SUBJECT: WATTS BAR NUCLEAR PLANT - RESPONSES TO RAI REGARDING
SPENT FUEL POOL COOLING ANALYSIS METHODOLOGY (TAC NO. MB1884)

ENCLOSURE 1
TENNESSEE VALLEY AUTHORITY
WATTS NUCLEAR PLANT (WBN)
UNIT 1
DOCKET NO. 390
RESPONSES TO NRC REQUEST FOR ADDITIONAL INFORMATION

FIGURE 1

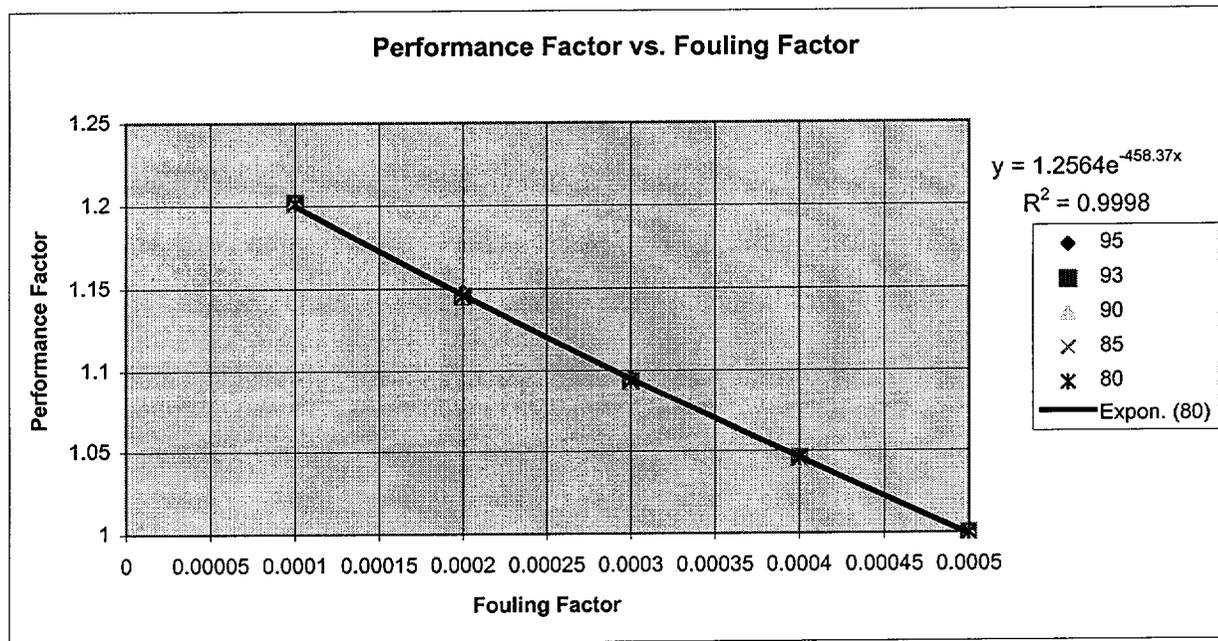
1. TVA states in Section III of Enclosure 1 "Proposed Methodology Change - Description and Evaluation of the Proposed Change" that "Analyses have been performed that support the proposed change." Please provide these analyses or a summary of these analyses, including the methodology (e.g., equations, code, how to determine heat exchanger heat removal capability, etc.), important assumptions and results.

The following figure depicts the relationship of Performance Factor to fouling factor, and also shows the independence of fouling factor to changes in CCS temperature. Note that all data for varying CCS temperature from 95°F to 80°F is superimposed on the graph as shown in Figure 1, clearly demonstrating that the performance factor for fouling is independent of CCS temperature.
